# **Environmental Impact Statement for the License Renewal of the Columbia Fuel Fabrication Facility in Richland County, South Carolina**

Final Report

**Figure 3-11 Gross Beta in Gator Pond Water Samples (Source: WEC 2019-TN6571 WEC 2021-TN7110)**

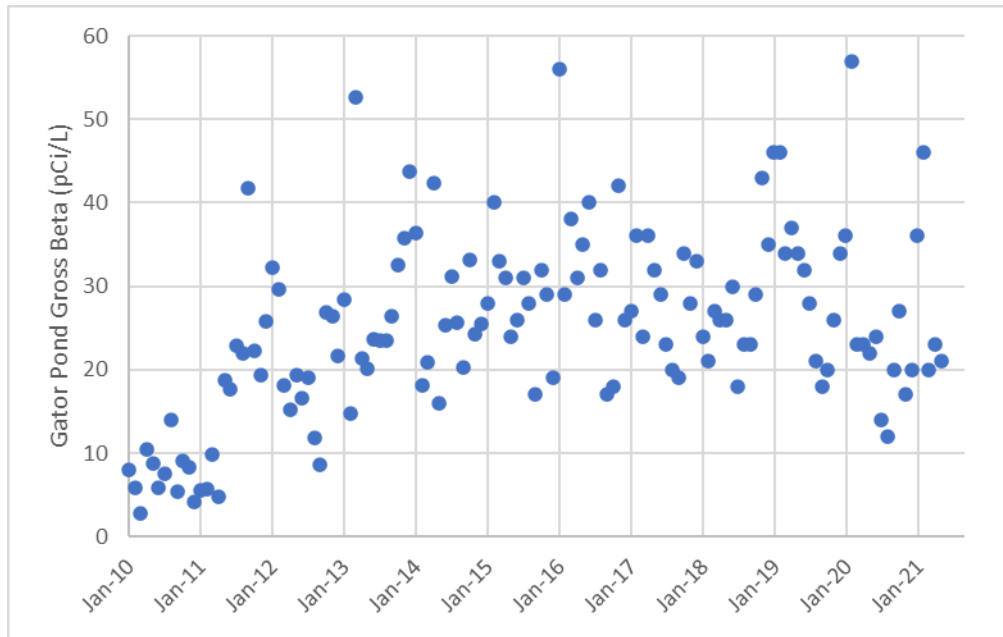
**Comment:** The DEIS section 3.4.1.2.2 "Gross Beta and Technicium-99" needs to discuss the historical source of Tc-99 from previous decades, and why gross beta counts at Gator Pond (i.e., Fig 3-11) are basically constant over time after an initial short increasing trend around 2010 and not decreasing afterward. We recommend that the Final EIS provide a more in-depth discussion regarding the history of Tc-99 at Gator Pond. (34-2-13 [Fite, Mark])

**Figure 3-15 PCE Concentrations in the Surficial Aquifer (for reference, the PCE MCL is 5 µg/L). The AS/SVE System Operated from 1998 to 2010 (Sources: AECOM 2013-TN5508, AECOM 2017-TN5512; WEC 2019-TN6510, WEC 2020-TN6526, WEC 2020-TN6875)**

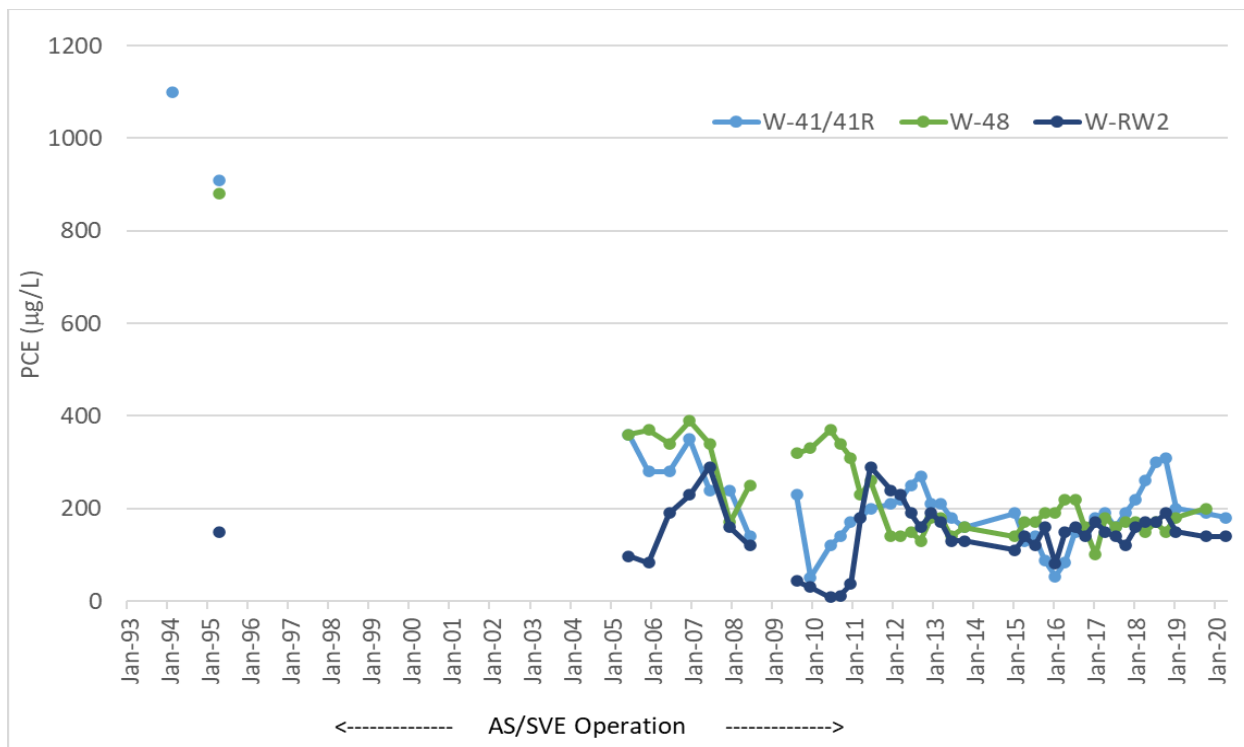
Current Wording: Figure 3-14 PCE Concentrations in the Surficial Aquifer

Justification: Since 2004, CFFF has consistently monitoring VOCs in four site wells (W-26, W-41R, W-48, and W-RW2) as required by the site's NPDES permit issued by SCDHEC. Figure 3-14 excludes data for W-26. The correct well designation is W-41R.

Figure 3-16 Uranium in the Surficial Aquifer, October 2021 (Source: WEC 2022-TN7155)

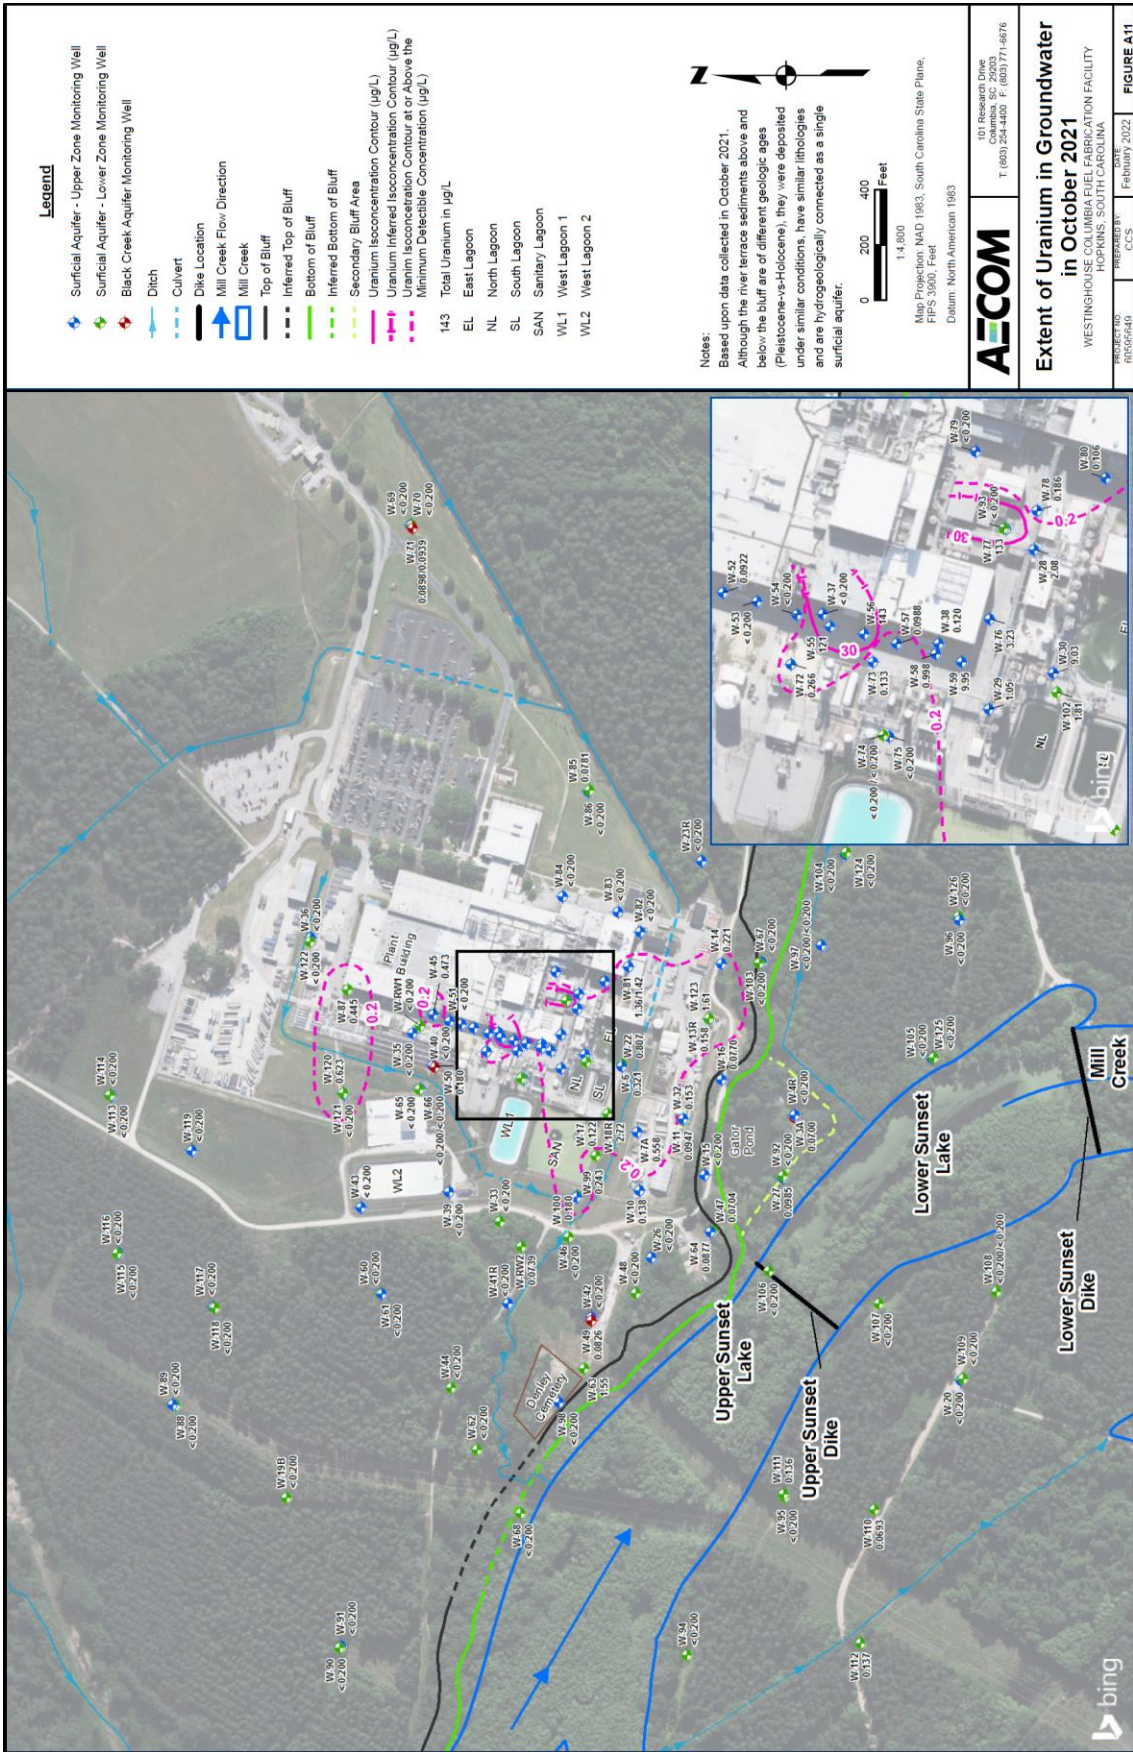
**Comment:** The current distribution of wells is insufficient to detect plume dispersal to the SE of the plant via hyporheic exchange (and subsequent SE flow) with Mill Creek. In Figure 3-16, for example, there are two Tc-99 plume lobes to the ESE (and WSW) that are not well bounded by monitoring sites; this same area is lacking wells in Figure 2-10 (see the area above the number "8"). This is important because, while groundwater pressure gradients may suggest SW flow, hyporheic exchange and flood transport likely deflect contaminant transport to the SE in surface and very near surface environments. In addition to this general area, we recommend inclusion of additional monitoring wells allowing for a longer distance perimeter around the site (perhaps including sampling wells at CONG) to ensure a zero-detection radius. (21-17 [Stanley, Joyce])

**Figure 3-18** Gross Beta (open circles) and Tc-99 (filled circles) Activity at the Well Pair W-32 (red) and W-11 (blue) (Source: WEC 2020-TN6875, WEC 2021-TN7112, WEC 2022-TN7155)

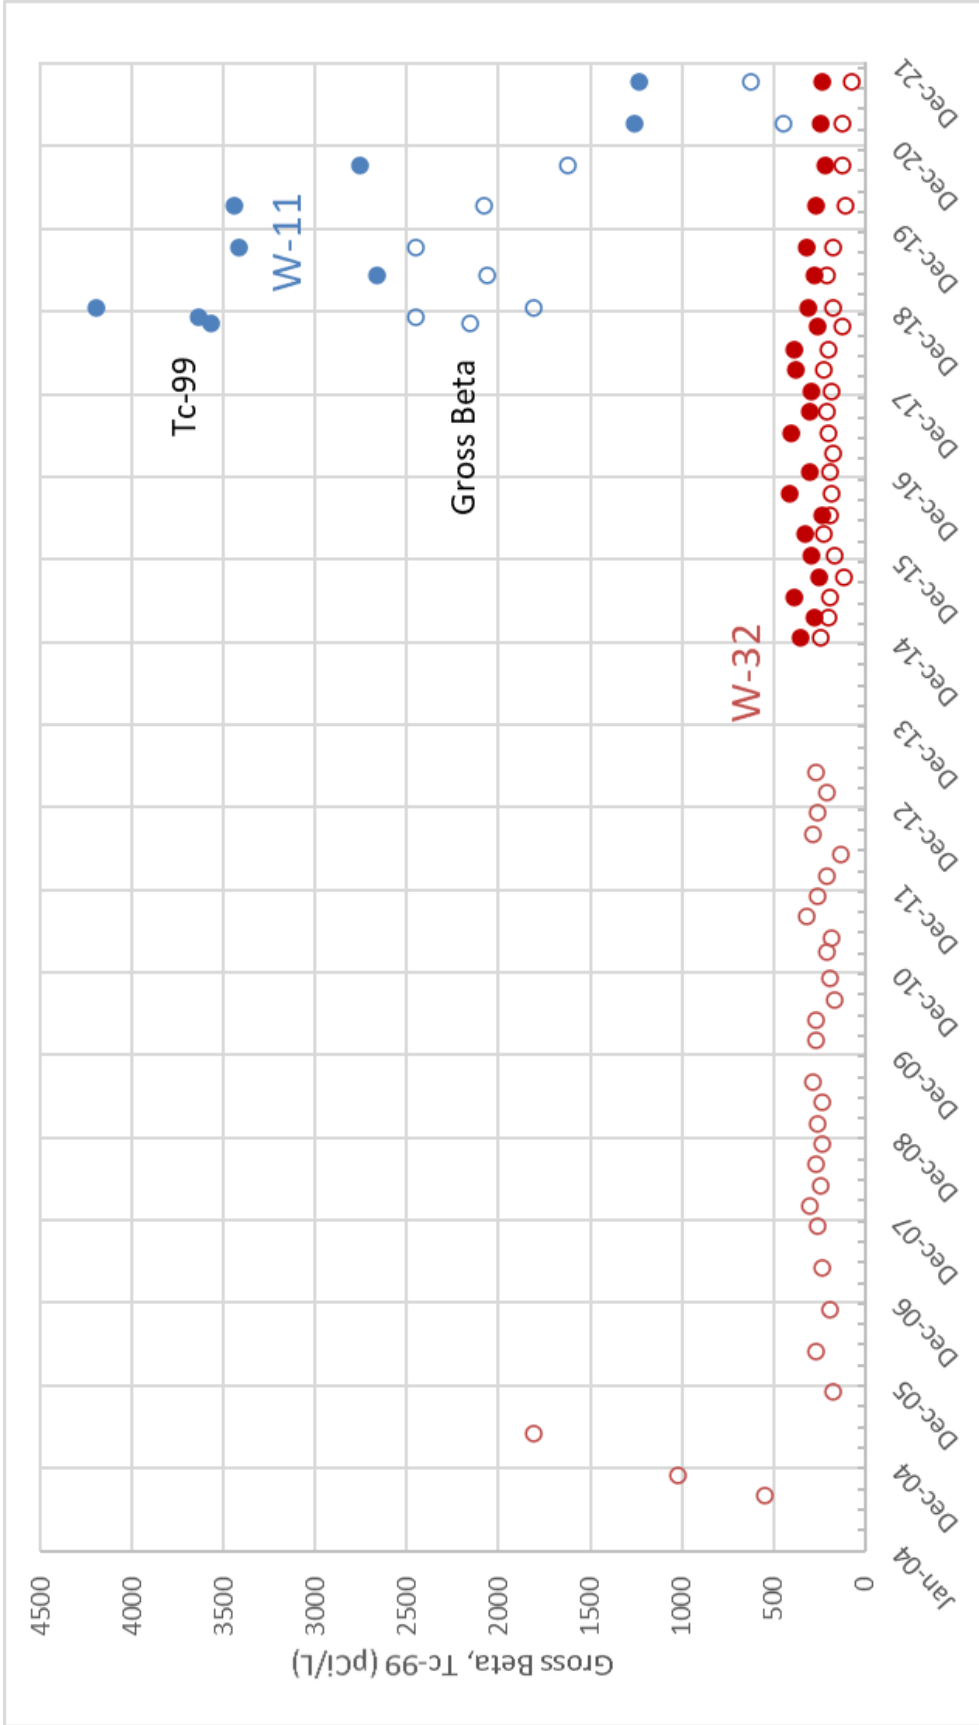
Current Wording: "Figure 3-17 Gross Beta (open circles) and Tc-99 (filled circles) Activity at the Well Pair W-32 (red) and W-6 (blue) (Source: WEC 2020-TN6875)."

**Figure 3-20 Radar Plot of  $\chi/Q$  Values at 1 Mile from the Site Boundary**

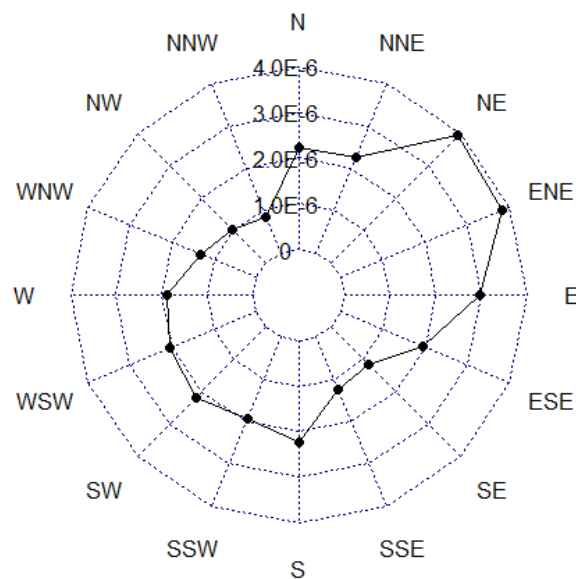
Line: Figure 3-20
